UNITED STATES PATENT AND TRADEMARK OFFICE

Office Action Summary	Application No. 10/590,982	Applicant(s) MIMURA, IKUO	
	Examiner GERARD T. HIGGINS	Art Unit 1794

DETAILED ACTION

Fig. 1

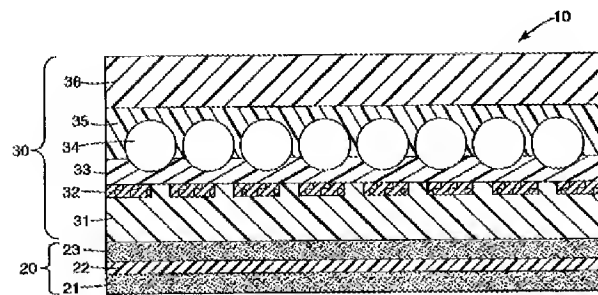
With regard to claim 1, Hingsen-Gehrmann et al. disclose the tamper-indicating articles, which read on applicants' display device, of Figures 1, 2, and 5.

The device is comprised of a top film **70**, which reads on applicants' surface-protective layer, a print layer **60**, which reads on applicants' information display layer, the layers **33** through **36**, which together read on applicants' light-reflective resin sheet, and an adhesive layer **20**, which reads on applicants' substrate adhesive layer [0034]-[0052], [0069] and [0079]. There is a reflective layer **31**, which reads on applicants' specular reflective layer, that is overlapping the light-reflective resin sheet via a release layer **32**, which reads on applicants' destructive layer installed on one side thereof, and the device is installed on an substrate **90**, which reads on either of applicants' auxiliary

substrate or installation substrate, via the adhesive layer; further, when the device is tampered with it results in the structure seen in Figure 2 [0072]. Hingsen-Gehrmann et al. teach that their release layer is preferably made of polyesters [0059]. There is a destructive effect wherein separation takes place between the release layer and one of the other layers constituting the retroreflective sheet.

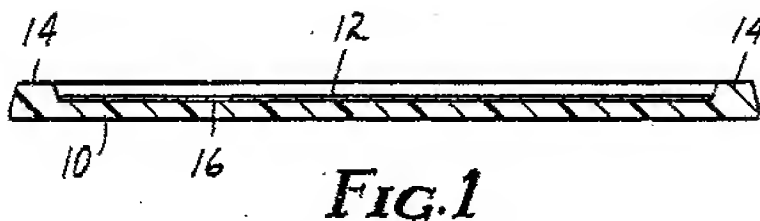
Chirhart et al. disclose an information plate having retroreflective sheeting of their Figure 1.

The article is comprised of a retroreflective sheeting **12**, which reads on applicants' display device, and plate blank **10**, which read on applicants' auxiliary substrate (col. 3, line 65 to col. 4, line 2). It is clear from the Figure that the auxiliary substrate is a size

larger than said display device and the auxiliary substrate is capable of wrapping around or wrapping-up said display device. This article is a license plate (col. 1, lines 15-17), which will be installed somewhere on a car, typically a bumper. The fact that a license plate is installed, i.e. mechanically fixed, on a car or a car bumper is intrinsic in the reference and would be known to those of ordinary skill in the art. The car or its bumper would read on applicants' installation substrate.

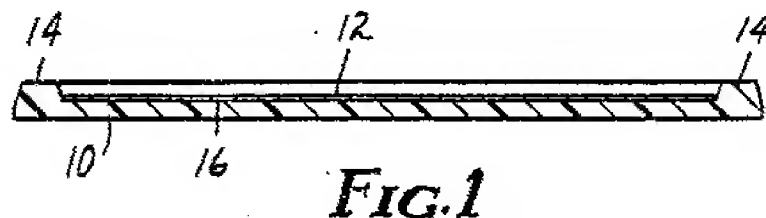
Chirhart et al. disclose an information plate having retroreflective sheeting of their Figure 1.

The article is comprised of a retroreflective sheeting **12**, which reads on applicants' display device, and plate blank **10**, which read on applicants' auxiliary substrate (col. 3,

line 65 to col. 4, line 2). It is clear from the Figure that the auxiliary substrate is a size larger than said display device and the auxiliary substrate is capable of wrapping around or wrapping-up said display device. This article is a license plate (col. 1, lines 15-17), which will be installed somewhere on a car, typically a bumper. The fact that a license plate is installed on a car or a car bumper is intrinsic in the reference and would be known to those of ordinary skill in the art. The car or its bumper would read on applicants' installation substrate.
